For: *OPTICAL TRANSCEIVER MODULE WITH POWER  
INTEGRATED CIRCUIT*

Patent No.: 7,359,643 B2

**REQUEST FOR A CERTIFICATE OF CORRECTION**  
**UNDER 37 C.F.R. § 1.323**

## UNITED STATES PATENT AND TRADEMARK OFFICE CERTIFICATE OF CORRECTION

**FIG. 2B**

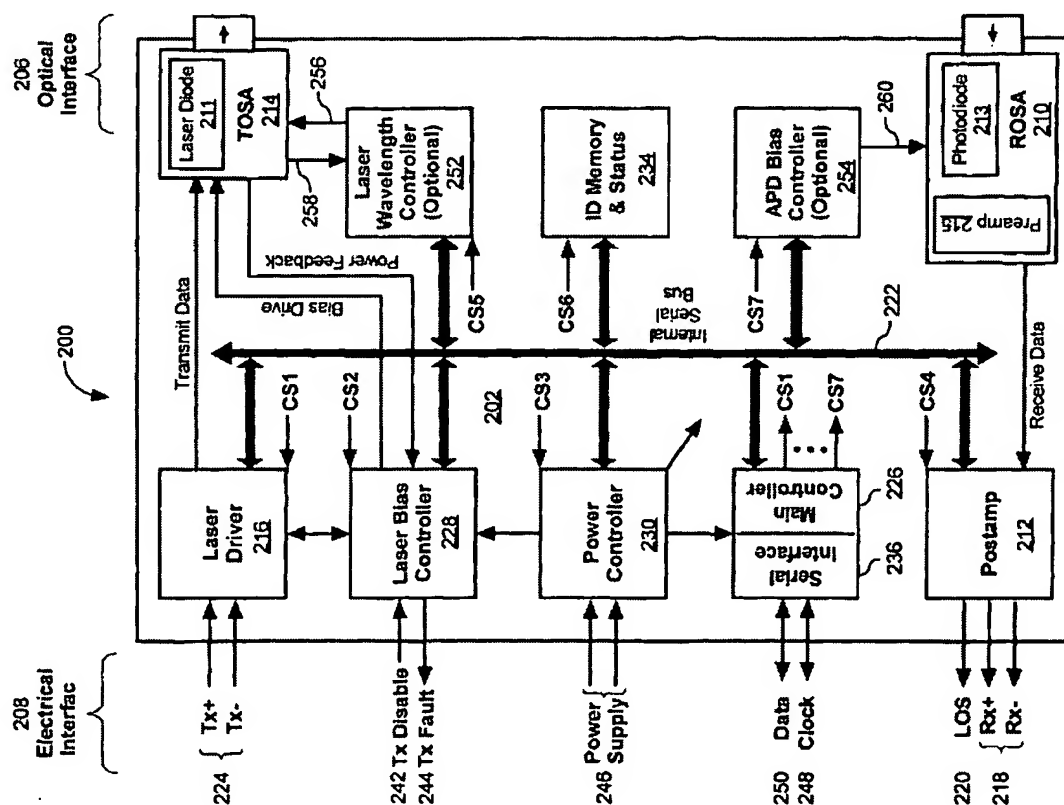
Sheet 3, replace Figure 2B with the figure depicted below, wherein preamp 215 has been added, laser temperature drive has been relabeled 256 and laser temperature or wavelength feedback has been relabeled 258

FIG. 2B

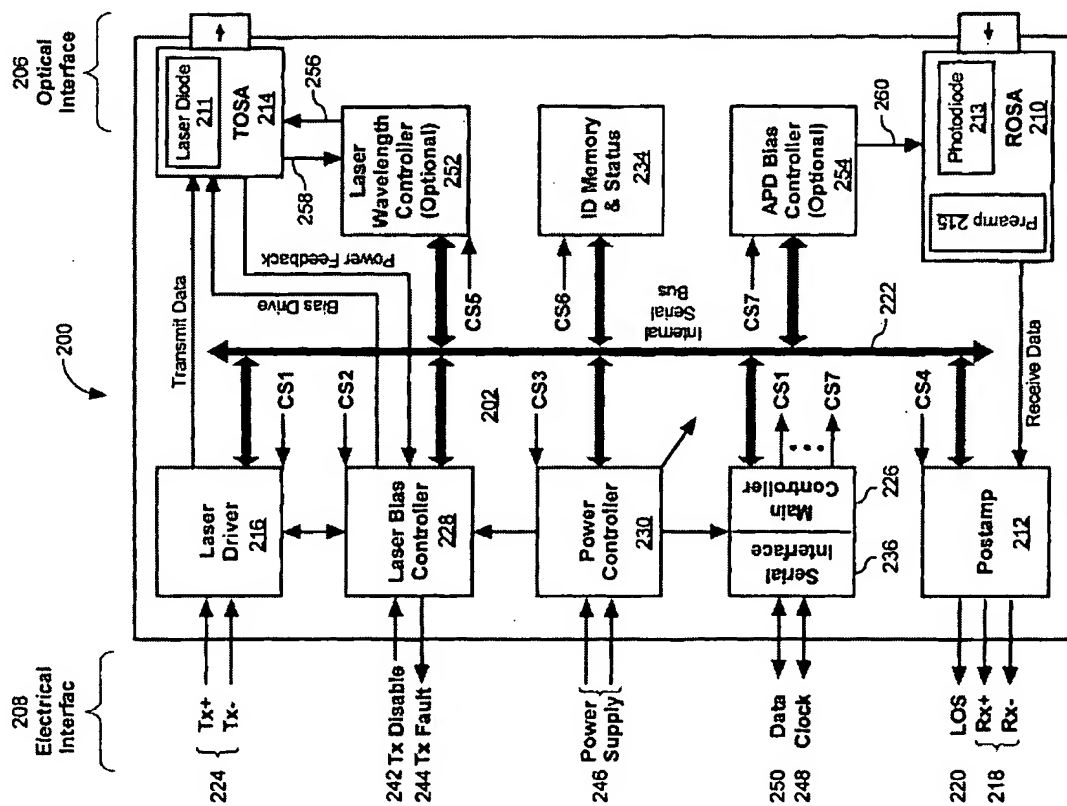
Sheet 3, replace Figure 2B with the figure depicted below, wherein preamp 215 has been added, laser temperature drive has been relabeled 256 and laser temperature or wavelength feedback has been relabeled 258
